COMMENT REPORT

CASE NUMBER: CD-2020-0002

PROJECT NAME: Brodie Oaks Redevelopment

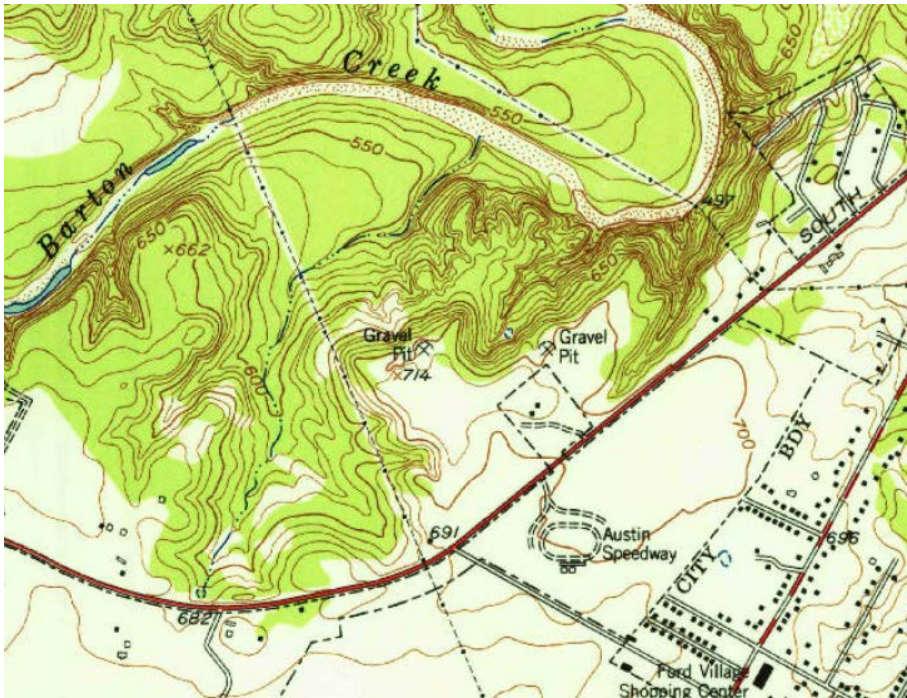
- EV12. 25-8-341/25-8-342: In addition to comments EV 10 and EV 11, according to aerial imagery as far back as 1955 (see below), the site was a gravel pit for several decades prior to the existing development. Historically, it has been the interpretation of Staff that grading in excess of four feet to restore pre-development grades is an acceptable exemption to City Code 25-8-341/342. Remove this proposed code modification from the proposed PUD application.

Figure 1. 1972 – cave passage survey

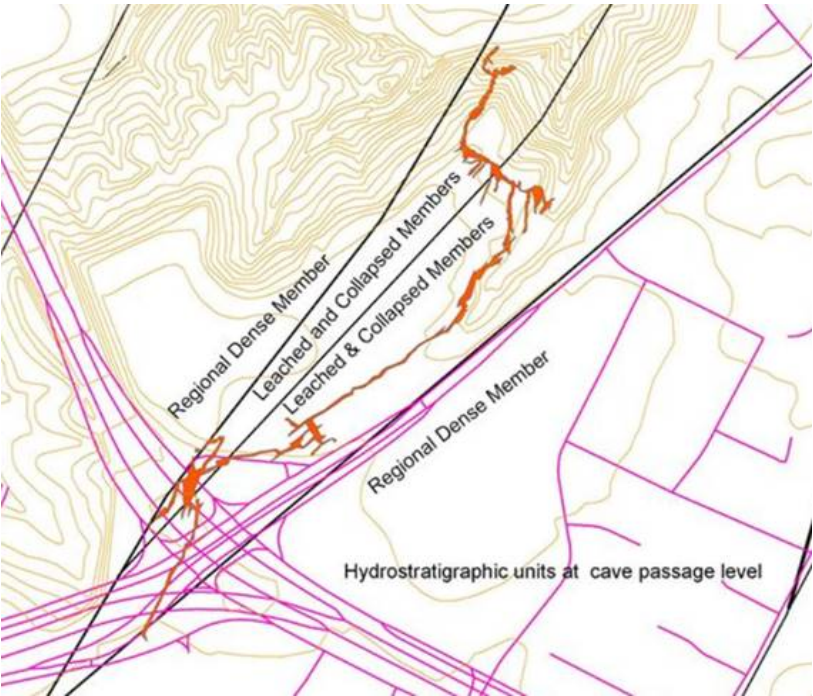
- HG 1. At this time, site specific information is unavailable or inaccurate regarding vegetation, areas of steep slope, or other environmental features such as bluffs, springs, canyon rimrock, caves, sinkholes, and wetlands. For example, the Environmental Resource Inventory Report prepared does not identify Airmans Cave, which is a cave listed on the City of Austin's 10A Permit. The cave passage is located beneath the site and is within 150-ft. The approximate location of cave passage is shown in map view below (Figure 1). Please be advised that according to Nico Hauwert, the 1972 survey map shown in red was not done with inclination measurements, so the actual horizontal distances are shorter than shown on the map, and one cannot determine rise in the cave passage from the entrance from the 1972 map. In 1995/1996, Mark Sanders, Jim Kennedy and Nico Hauwert remapped 2/3 of the Cave. The profile attached shows the cave depth relative to the surface for the first 2/3 of the cave were surveyed (Figure 2). The attached map compares their survey (green dots) to the red scan of the 1972 cave map (Figure 3). Please update the ERI report

to include Airmans Cave and any protective measures proposed to preserve the cave itself and the water quality and water quality in the cave.

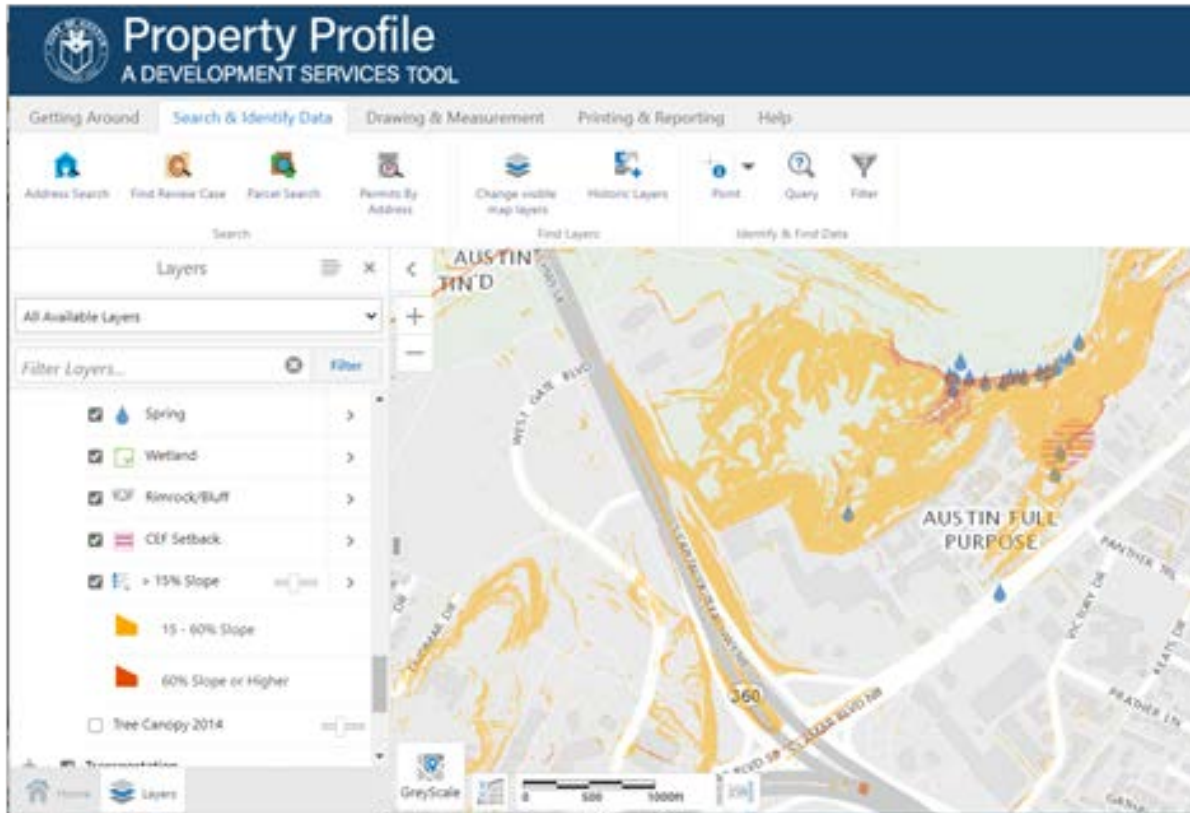
- HG 2. Please be advised that Airman’s Cave is listed on the City’s 10A Permit and contains species of concern. Additional requirements regarding compliance with the BCCP may apply. Please coordinate with Kimberlee Harvey and Austin Water regarding possible BCCP compliance requirements.
- HG 3. Please be advised the void and water flow mitigation rule applies to this site.
